HISTORIC AND DESIGN REVIEW COMMISSION

August 17, 2022

HDRC CASE NO: 2022-291
ADDRESS: 801 N MAIN AVE
LEGAL DESCRIPTION: NCB 787 BLK 7 LOT 15- 16 & S TRI 53.79 FT OF 10
ZONING: D
CITY COUNCIL DIST.: 1
APPLICANT: Robert Flores/American GI Forum-National Veterans Outreach Program, Inc.
OWNER: American GI Forum-National Veterans Outreach Program, Inc.
TYPE OF WORK: Construction of a 4-story residential structure
APPLICATION RECEIVED: August 01, 2022
60-DAY REVIEW: Not applicable due to City Council Emergency Orders
CASE MANAGER: Edward Hall

The applicant is requesting a Certificate of Appropriateness for approval to construct a 4-story, residential structure at 801 N Main, located within the Downtown Design District.

2 West Elevation
SCALE: 1/8" = 1'-0"

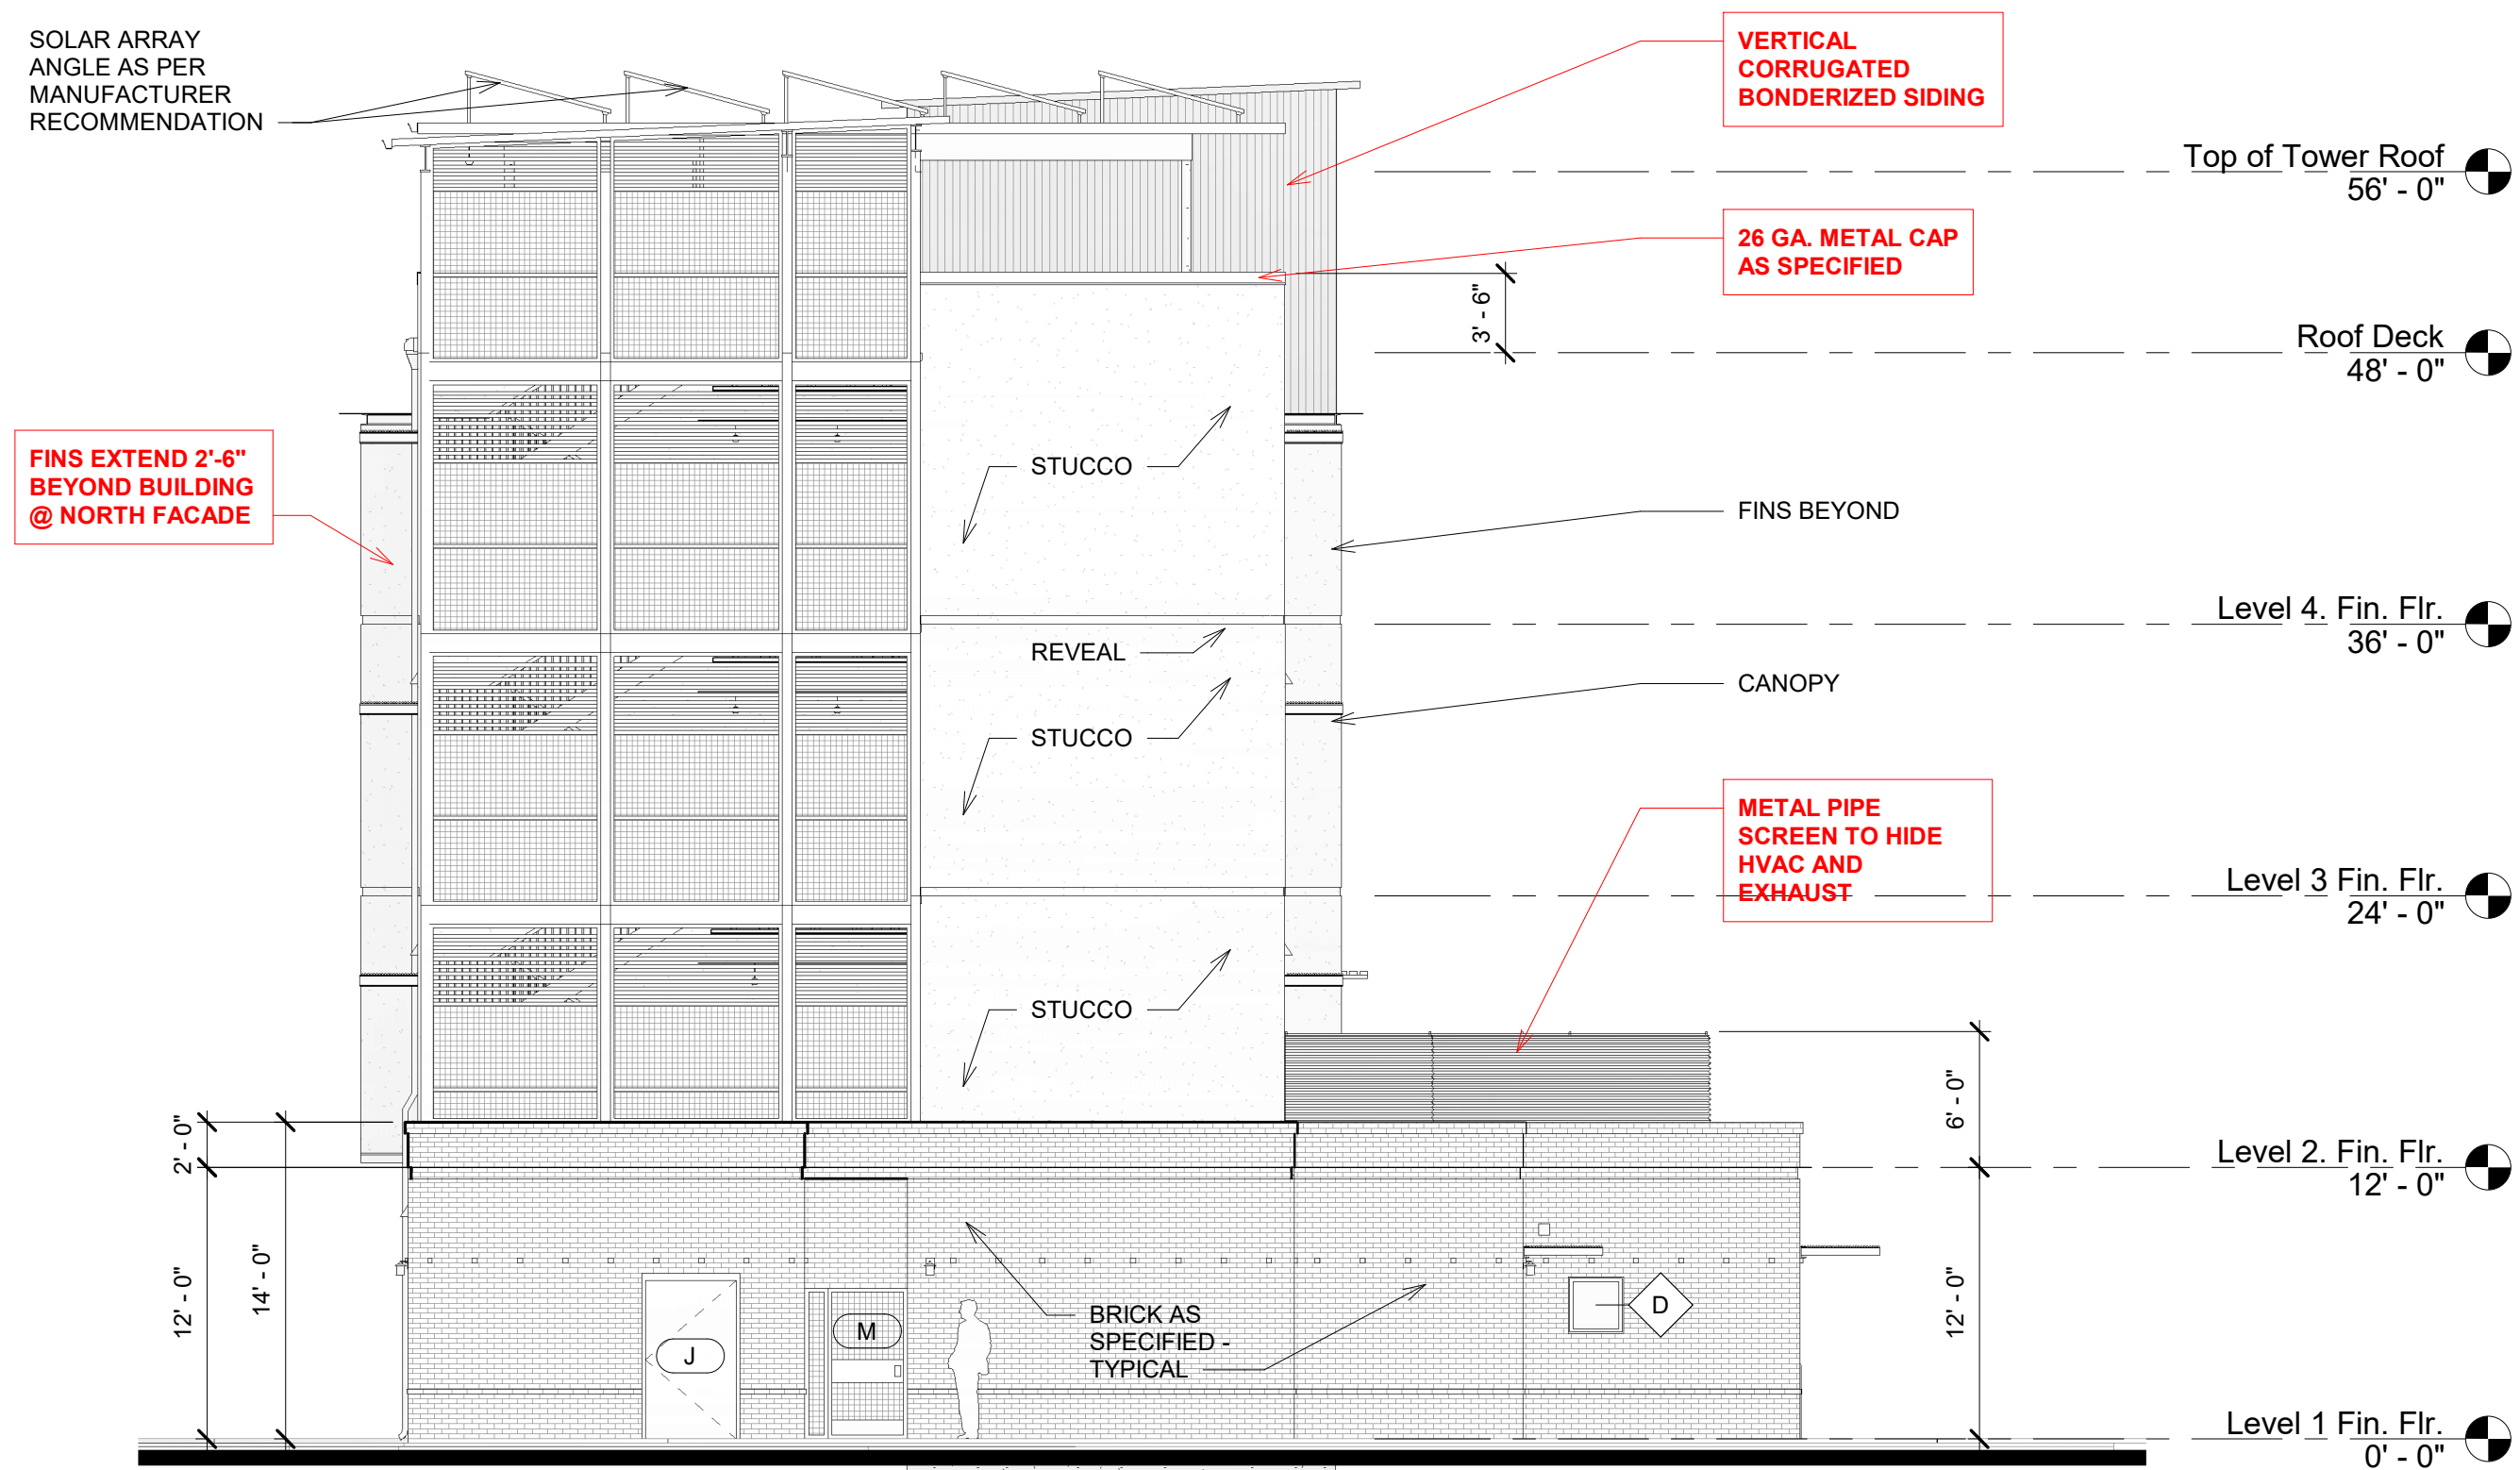
- iii. That the applicant introduce architectural elements to the north façade to break up the façade and that the applicant introduce architectural elements, such as a cornice to create a building cap, as noted in finding i. A change in materials or material profile and color should be explored to meet these requirements. *This stipulation has been met.*

- j. MASSING & STREET WALL – The applicant has proposed for the structure to feature four (4) stories in height. The Downtown Design Guide 5.A.i. notes that large building facades should be divided so that no building section is longer than 100 feet in length. Additionally, structures should feature a base, middle and cap,

should maintain the alignment of other horizontal elements on the block and should feature floor to floor heights similar to other structures on the block. Staff finds the overall massing of the proposed new construction to be appropriate as the applicant has proposed façade separating elements, a distinctive building base and cap and variations in material colors and textures.

- k. MATERIALS – The applicant has proposed materials that include brick, stucco, corrugated metal siding, metal screening, and aluminum windows. Generally, staff finds the proposed windows to be appropriate and consistent with the Downtown Design Guide.

- l. WINDOWS – The applicant has proposed anodized aluminum windows. The Downtown Design Guide notes that windows should add depth to a building's façade and should be well detailed where they meet façade materials to provide adequate weather protection and to create a shadow line. Staff finds that that windows should feature dark colored frames, no faux divided lites or faux internal grilles. For windows that are not surrounded by wall fins, staff finds that windows should be recessed at least two (2) inches within walls.
